Technical Service Information

THM 4L80-E

2ND GEAR STARTS AND NO LINE RISE

**HEAVY DUTY TURBINE SHAFT
AND O.D. CARRIER**

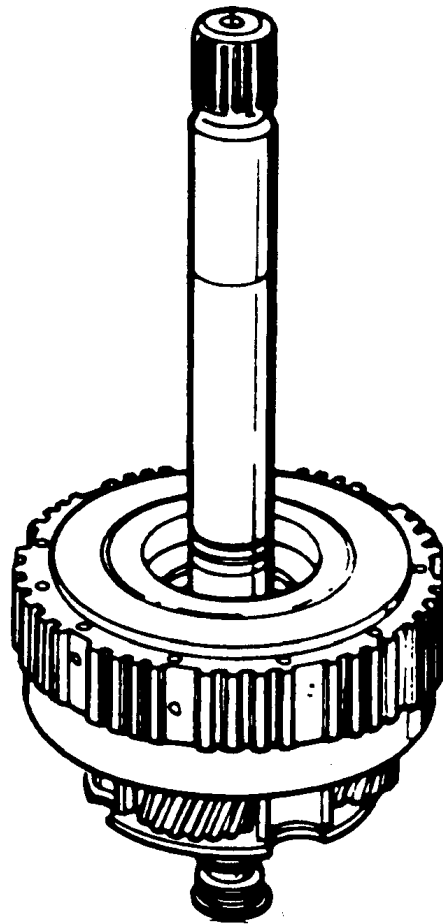
- COMPLAINT:** Some THM 4L80-E/4L80-EHD transmissions may exhibit a twisting or breakage of the turbine shaft and/or breaking of the O.D. carrier assembly, usually in "P" series cube vans.

- CAUSE:** The cause may be more torque load than the parts are capable of carrying, usually vehicle weight in heavy throttle conditions.
- CORRECTION:** There is now available from OEM a new service package that includes a heavy duty turbine shaft and overdrive carrier assembly. Refer to Figure 1. This service package, OEM part number 24200130, should be installed in "P" series cube vans, or any vehicle carrying a lot of extra weight.

| Turbine Shaft and O.D. Carrier Asm. (Heavy Duty) | 24200130 |
